Environmental Minor Project Refinement Form

Project Name: West of Devers Upgrade Project	Request Prepa	_ Request Prepared By: <u>Sylvia Granados</u>		
Date Approval Required: 12/14/2017	Variance Requ	Variance Request No.: 2		
Date Submitted: <u>12/13/2017</u> page 55 attached)		Location: Maraschino Telecom Route (see revised Figure 2,		
Landowner: <u>SCE ROW/City of Beaumont</u>		rcel Number:		
Current Vegetative Cover/Land Use: <u>Developed/Disturbed Land/Single-Family Residential</u>				
Existing Sensitive Resource? NO ■ YES Specify: See "Biological Resources"				
Modifying (check as many as apply):	☐ MITIGATION MEASURE ■ DRAWING	☐ PLAN/PROCEDURE ☐ S		
Specify Source (e.g., Mitigation Measure B.5): NTPR #3 Figure 2, Page 55				
Description of Change and Justification (Attach additional sheets if needed.) Attachments: ■ CONSTRUCTION DRAWING □ ADDITIONAL ENVIRONMENTAL ANALYSIS □ CORRESPONDENCE □ OTHER:

Southern California Edison West of Devers Upgrade Project MPR #2 - Work Areas for Maraschino Telecom Manholes/Vaults

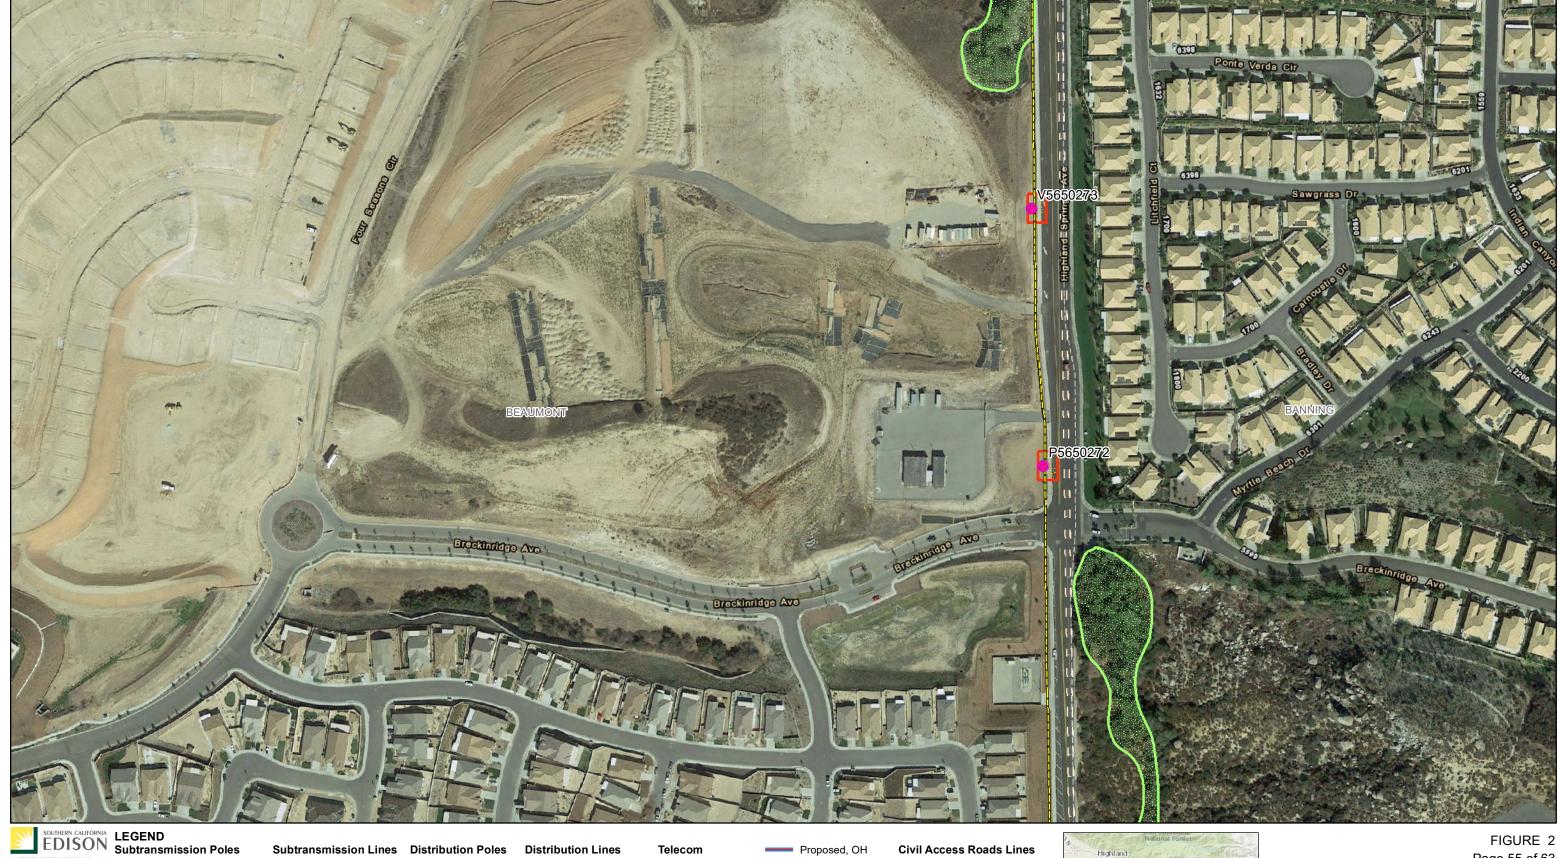
NTPR #3 Map Figure 2, page 55 has been revised to reflect the addition of two temporary work areas (approximately 60-feet by 60-feet each) for access to two existing manholes/vaults along the project alignment on Highland Springs Avenue, to locate existing conduit for cable pulls and connections, in the City of Beaumont, Riverside County. The temporary work areas are in disturbed land, currently under development and do not create new significant impacts for the project.

The area surrounding the two-access manhole/vaults along Highland Springs Avenue, between Crooked Creek Road and Breckenridge Avenue, is currently under development. The designated work areas for the manhole/vaults measure approximately 60 feet by 60 feet and are located within previously disturbed or developed areas. This portion of the alignment is located in an urbanized part of Beaumont, between the Highland Springs Avenue right-of-way and a residential development. No ground disturbing activities are planned. Construction workers will park vehicles on the shoulder of the public road or on previously disturbed/developed areas and access the manhole/vaults on foot. Therefore, no direct impacts to special-status species habitats are anticipated. Likewise, due to the nature of the construction activities and absence of suitable habitats for special-status plants and special-status terrestrial wildlife, no impacts to these species are anticipated.

The manhole/vault locations are within 500 feet (north and southeast) of habitats presumed to be historically occupied by the least Bell's vireo (LBVI) (*Vireo bellii pusillus*) and southwestern willow flycatcher (SWFL) (*Empidonax traillii extimus*). However, construction activities at these manhole/vaults are not expected to occur during the breeding season for these species. In addition, the activities are low impact. Therefore, no direct or indirect impacts to breeding LBVI or SWFL are anticipated. SCE will conduct focused nest location surveys as required by MM WIL-1c and consistent with the project Nesting Bird Management Plan (NBMP) beginning January 1. If a breeding territory for LBVI or SWFL is identified, SCE will implement avoidance and minimization measures consistent with MM WIL-2c, in coordination with the RCA, CDFW, and USFWS, in accordance with the NBMP.
